Newmar Corporation Warranty Department

Technical Service Bulletin							
Date Issued	Model Year(s) Affected	Model(s) Affected			TSB #		
10/23/2006	2004 2005 2006	Workhorse 8.1 L gasoline engines			304		
Brand					Type		
All ☒	American Star ☐	Dutch Star ☐	Kountry Star ☐	Mountain Aire ☐	Kountry Aire ☐	Essex ☐	
Scottsdale ☐	Northern Star ☐	London Aire ☐					
☐ Air Conditioning & Heating ☐ Appliances & Accessories ☐ Cabinets & Furniture ☒ Chassis Components ☐ Construction Components ☐ Electrical Components ☐ Exterior Components ☐ Interior Components ☐ Plumbing & Bath Components ☐ Windows, Awnings, Vents, & Doors							
Description of Problem							
Possible installation of an improperly heat treated fuel rail damper retainer clip. The retainer clip on the subject engines may fracture without warning, resulting in inadequate retention of the damper. If the damper becomes loose, pressurized fuel may spray onto the engine.							
Recommended Solution

WORKHORSE CUSTOM CHASSIS SERVICE BULLETIN

SUBJECT: 8.1 L Engine Fuel Rail Damper Retainer Clip

Photo 1 Black cap on pressure valve on fuel rail on top RH side of Engine

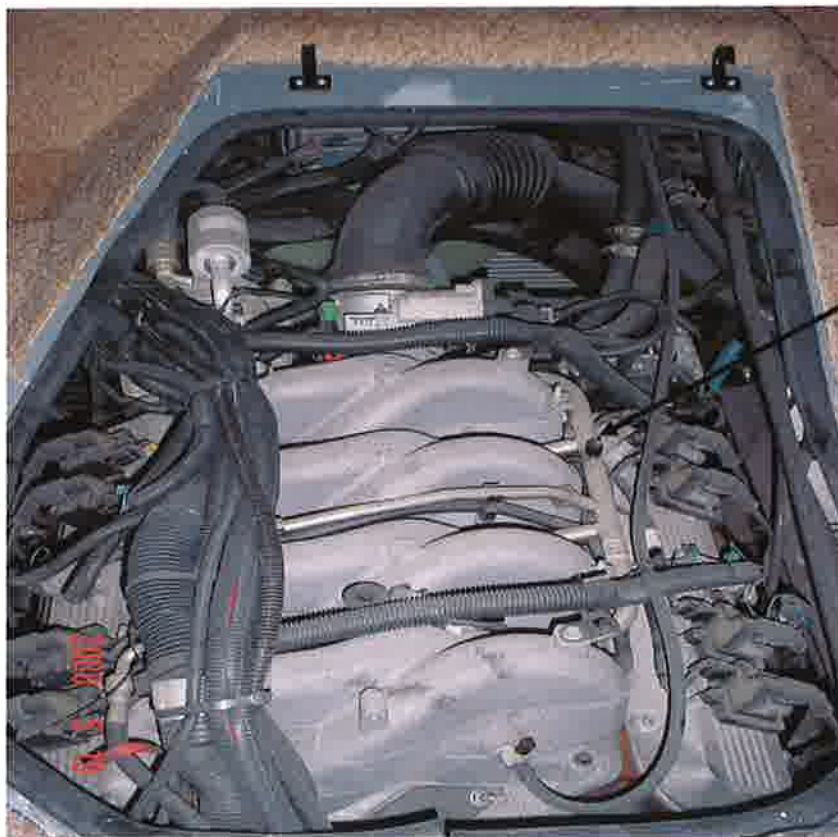
4. Loosen the fuel filler cap in order to relieve the tank vapor pressure.
5. Relieve any residual fuel pressure through the fuel pressure connection valve shown by photo 1 using a fuel pressure gage, or equivalent, and an approved fuel container. Wrap a shop towel around the fitting while connecting the gage in order to avoid spillage.

Photo 2 and 3 retaining clip and damper held by the clip

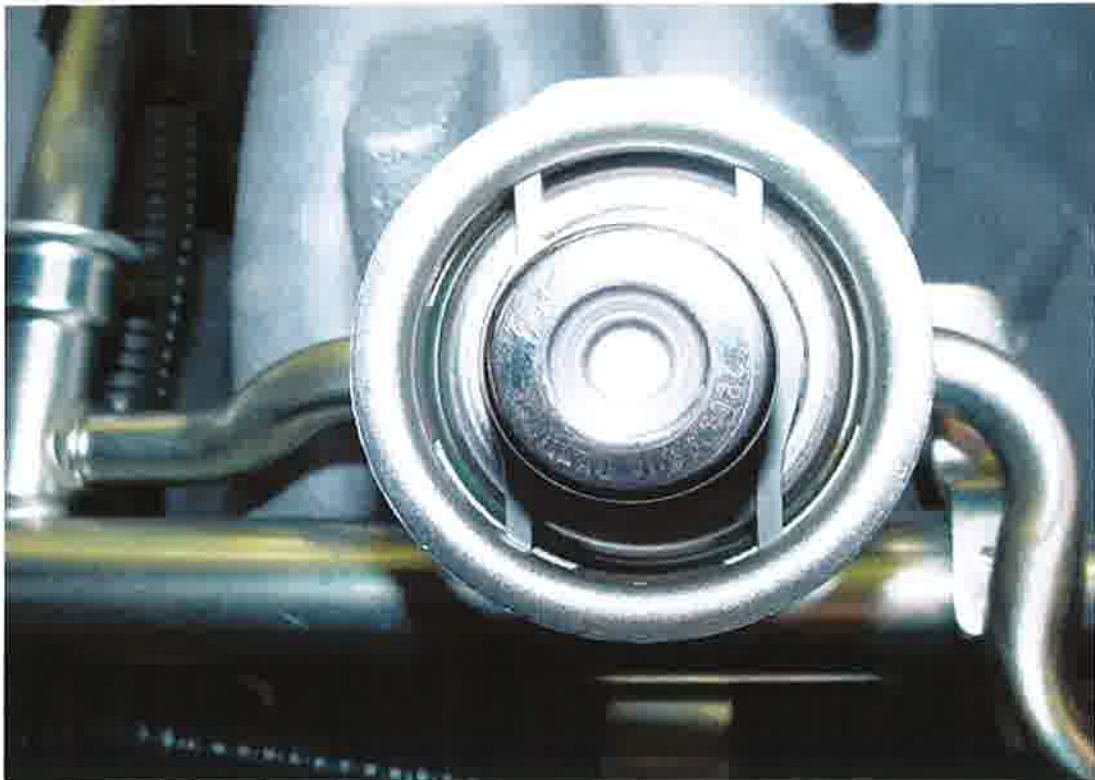
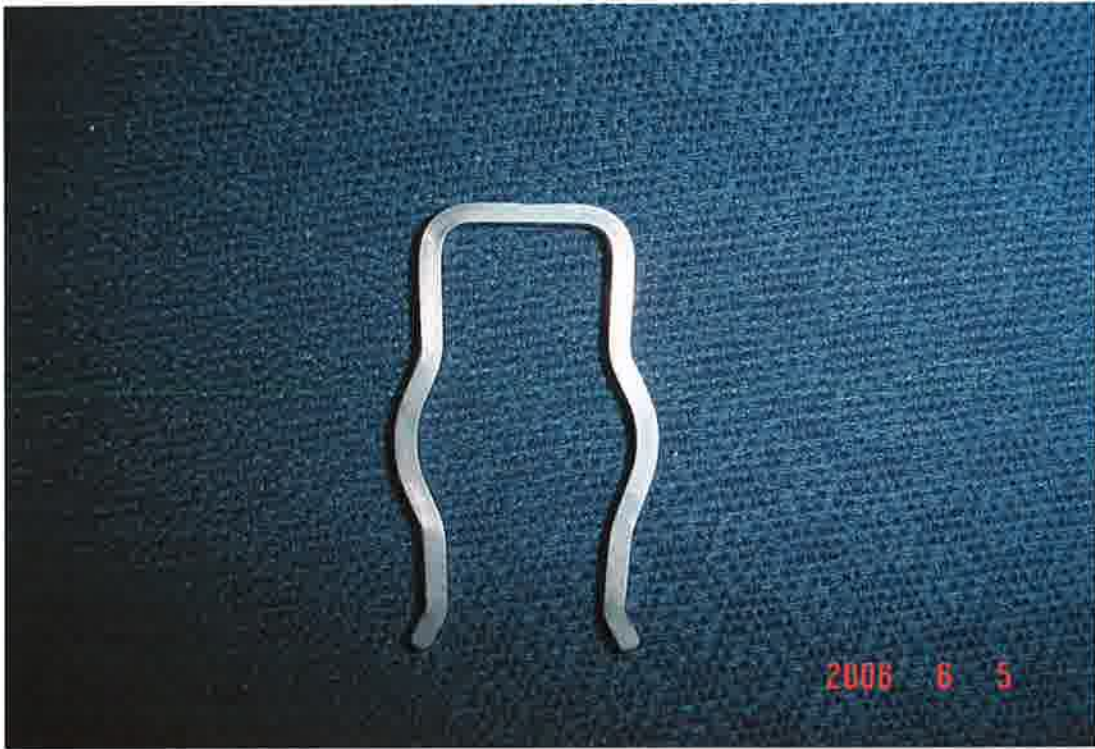
The defect involves the possible installation of an improperly heat treated fuel rail damper retainer clip. An improperly heat treated clip may break resulting in a gasoline fuel leak at the fuel rail damper. A vehicle fire can result if the leaking fuel is ignited by a spark, or flame.

6. Push down on the fuel damper while using a flat screw driver to remove the existing clip. (See photos 2 and 3)
7. Do not remove the fuel damper from the fuel rail. If the damper is removed the fuel damper o-ring must be replaced at the technician's/dealer's expense.

8. While holding down the damper, install the new clip in same position as removed clip.
9. Reconnect the negative battery cable.
10. Tighten the fuel filler cap.
